## **SOUTHERN INDUSTRIAL PARK SUBDIVISION,** **ADDITION TO**

Engineering Comments: FINAL PLAT COMMENTS (should be addressed prior to submitting the FINAL PLAT for review and/or signature by the City Engineer):

APPLICATION NUMBER 3 DATE December 20, 2018  
 APPLICANT Southern Industrial Park Subdivision, Addition to  
 REQUEST Subdivision

# DETAIL SITE PLAN

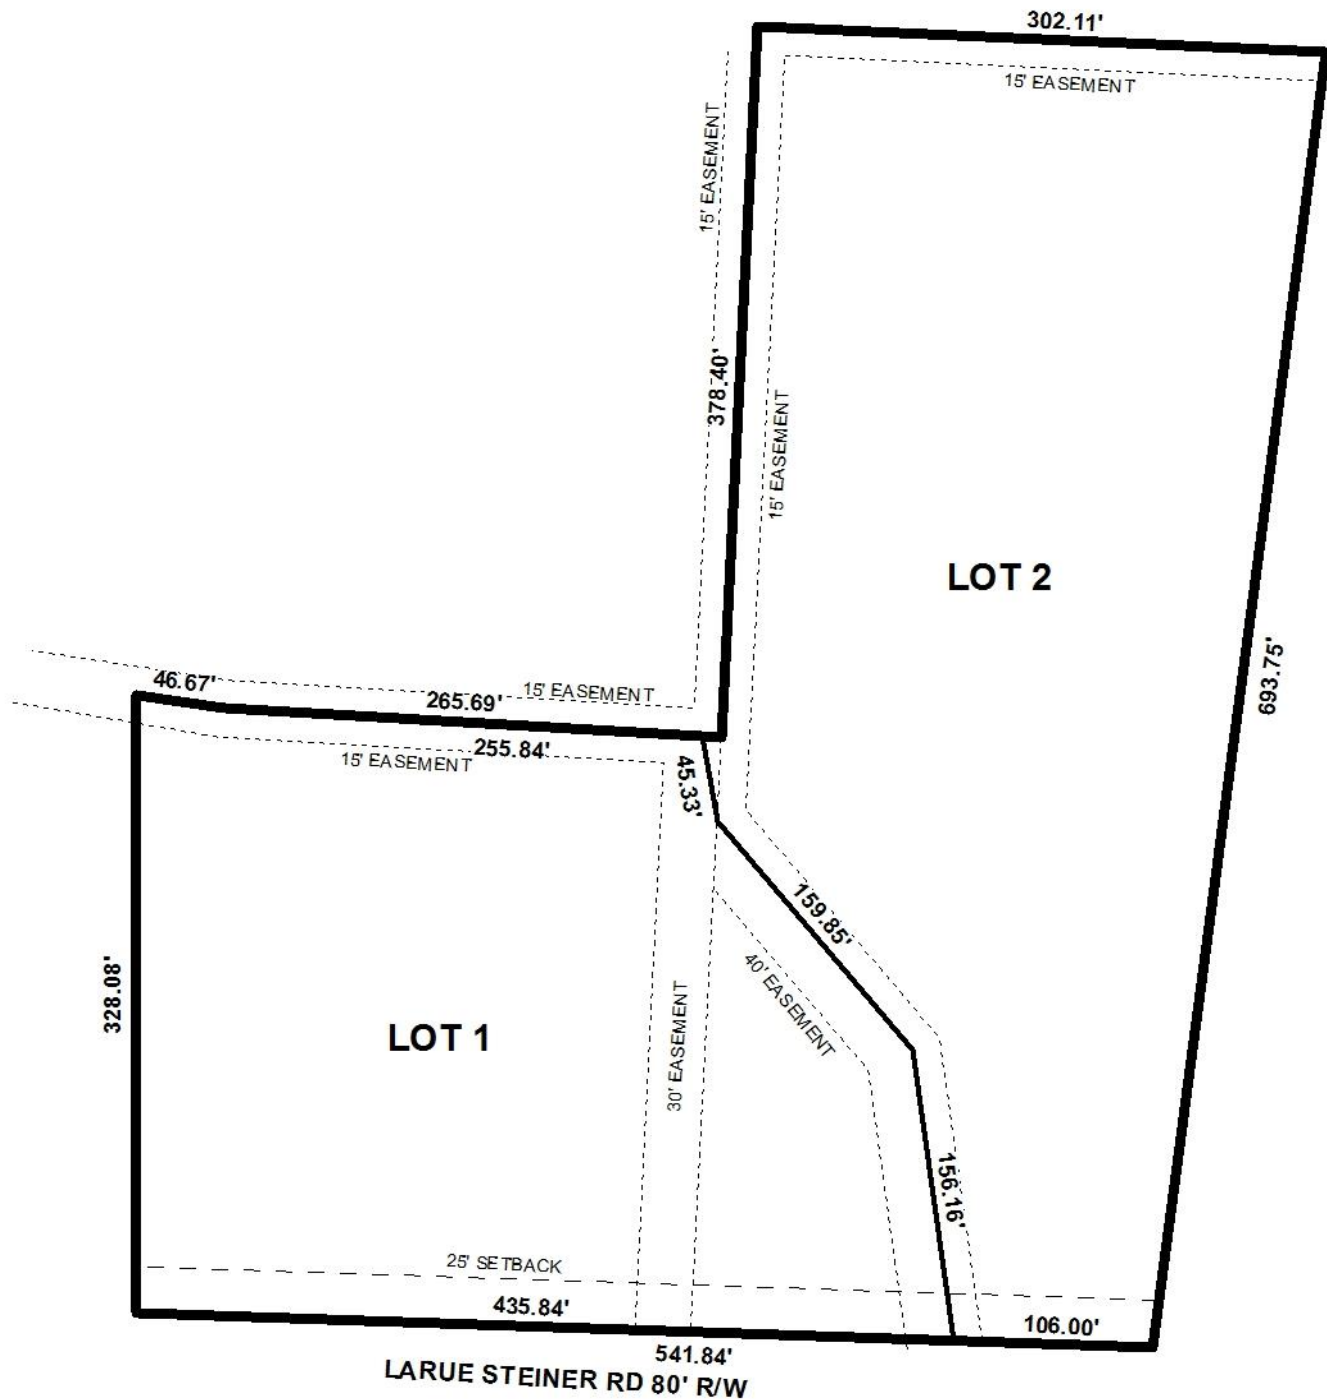
- B. Add a legible street name for LaRue Steiner Rd. on the vicinity map.
- C. Show and label the existing Lots 1, 2, and 5 that are referenced in the written legal description.

- D. Show and label each and every existing drainage easement within and adjacent to the proposed subdivision. There appears to be one adjacent to the NW corner of LOT 2.

- E. The proposed subdivision receives drainage from a public street and will require a PUBLIC (Dedicated to the City of Mobile) drainage easement. Additionally a DRAINAGE EASEMENT may be required along the front of LOT 1 and LOT 2. The width and alignment of the easement(s) shall be coordinated with, and approved by, the City Engineer before submitting the Final Plat for signature. The existing drainage ditch that runs through LOT 1 and LOT 2 needs to be contained in a PUBLIC DRAINAGE EASEMENT. Additional width may be required to allow vehicular and equipment access.

- F. Add the item labeled as "FC" to the LEGEND.
- G. Provide the Surveyor's, Owner's (notarized), Planning Commission, and Traffic Engineering signatures.

- H. Add a note to the plat stating that all proposed detention facilities, common areas, and wetlands shall be the responsibility of the Property Owner(s), and not the responsibility of the City of Mobile.

- I. Add a note to the plat stating that all easements shall remain in effect until vacated through the proper Vacation process.
- J. Provide a copy of the FINAL SUBDIVISION PLAT to the Engineering Dept. for review. No signatures are required on this drawing.

The proposed lots front Larue Steiner Road, a minor street. The preliminary plat illustrates a compliant 80' right-of-way width on Larue Steiner Road. If approved, the right-of-width should be retained on the Final Plat.

The preliminary plat depicts a 25' minimum building setback along Larue Steiner Road. If approved, the 25-foot minimum building setback should be retained on the Final Plat.

It should be noted that there are several drainage easements on the proposed lots. If approved, a note should be placed on the Final Plat stated that no structures should be erected in any easement on the site.

The proposed lots exceed the 7,200 square foot minimum lot size requirements for lots served by public water and sanitary sewer systems. The preliminary plat provides the lot size in square feet and acres. If approved, the lot size information should be retained on the Final Plat.

As a means of access management, a note should be placed on the Final Plat, stating that each lot is limited to one curb cut to Larue Steiner Road, with any changes in size, location and design to be approved by Traffic Engineering and conform to AASHTO standards. Any new on-site parking, including ADA handicap spaces, shall meet the minimum standards as defined in Section 64-6 of the City's Zoning Ordinance.

- 1) Retention of the 80' right-of-way width to Larue Steiner Road;
- 2) Retention of the 25' minimum building setback line along Larue Steiner Road;
- 3) Retention of lot size information in both square feet and acres;

- 4) Placement of note on the Final Plat stating that no structures should be erected in any easement;
- 5) Placement of a note on the Final Plat stating the following Traffic Engineering comments: *(Each lot is limited to one curb cut to Larue Steiner Road, with any changes in size, location and design to be approved by Traffic Engineering and conform to AASHTO standards. Any new on-site parking, including ADA handicap spaces, shall meet the minimum standards as defined in Section 64-6 of the City's Zoning Ordinance.);*
